POWER PLANT - ENGINE - INCORPORATION OF CLIPPING POINT 2449 AND BRACKET AT CLIPPING
POINT 2587 - CATEGORY CODE 6 - MOD.ENG-71-0149

V2500-ENG-71-0149

Location of clipping point 2449 and bracket for clipping point 2587
Fig.1 (Sheet 1 of 2)

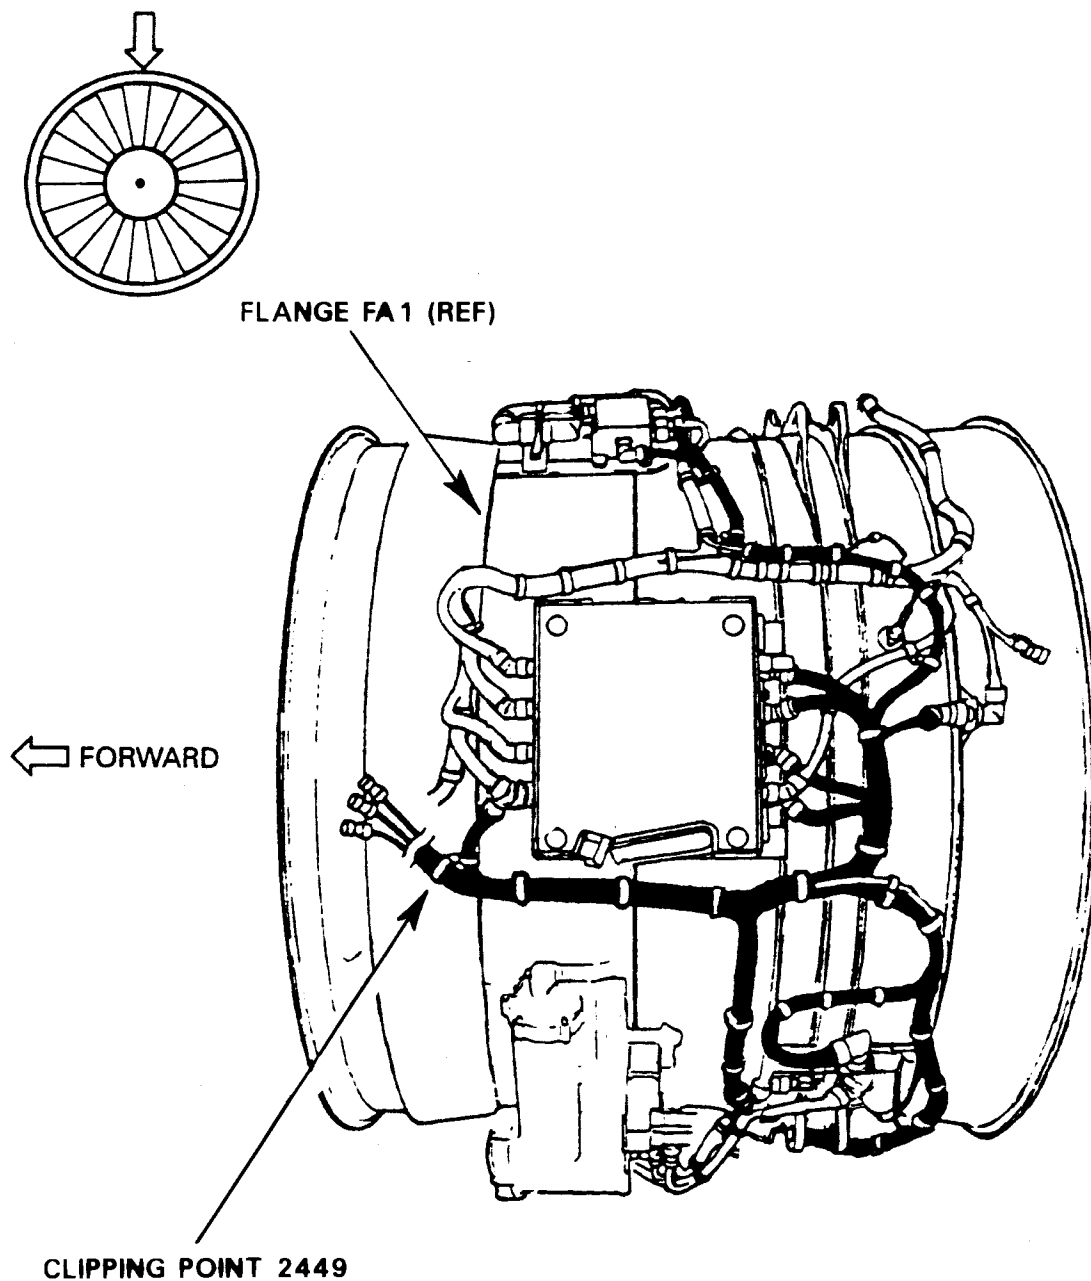
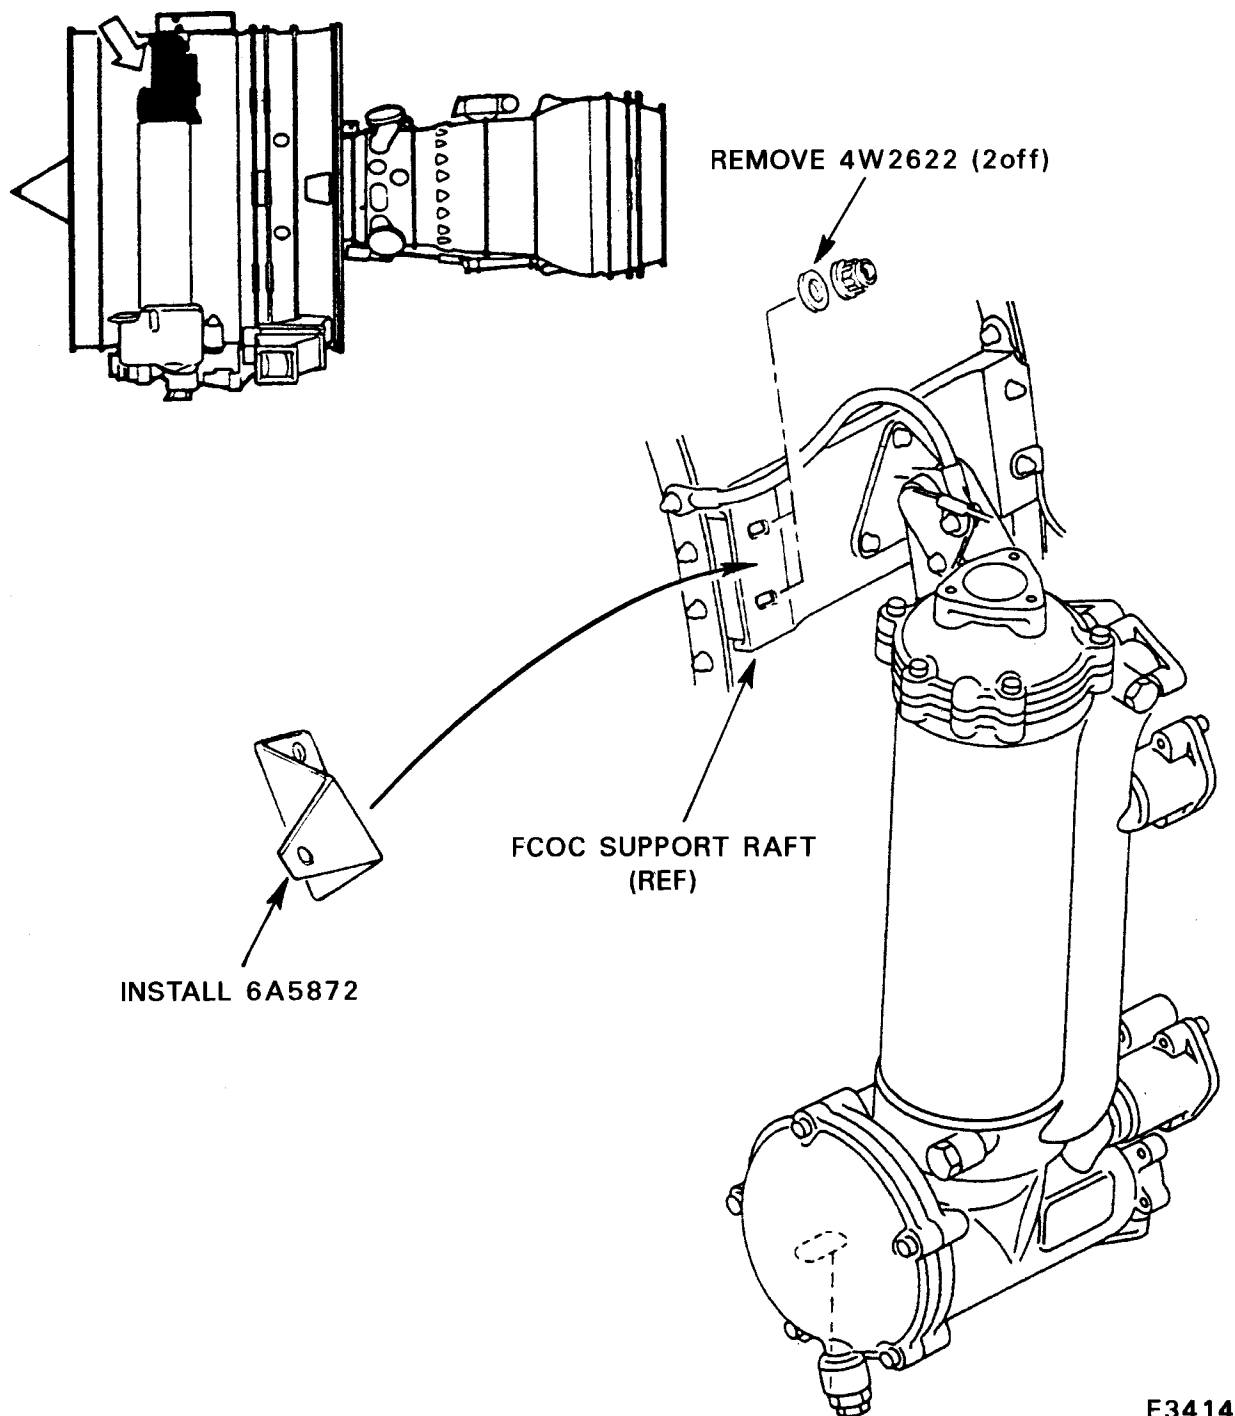
- (1) Clipping Point 2449 is added.
- (2) The Bracket at clipping point 2587 is added and the washers at the bracket location deleted.

- (1) Find the support bracket for clipping point 2449 on flange FA1. Refer to Figure 1 and Figure 2.
- (2) Install the 4W0135 bolt, the 6A4824 spacer, the AS62518 clip, the UP10480 spacer, the AS62511 clip, the UP10480 spacer and the 4W0043 clipnut at clipping point 2449. Torque the bolt to 36 to 45 lbfin (4 to 5 Nm). Refer to Figure 2 and Figure 3.
- (3) Find the 6A4631 fuel cooled oil cooler (FCOC) support raft. Refer to Figure 1.
- (4) Disassemble the bolts (2 off), washers (2 off) and nuts (2 off) that attach the 6A4631 support raft to the bracket on flange FA1. Discard the washers. Refer to Figure 1.
- (5) Install the new 6A5872 bracket on to the 6A4631 support raft, using the bolts and the nuts removed at step (4). Torque the nuts to 85 to 105 lbfin (10 to 12 Nm). Refer to Figure 1 and Figure 4.
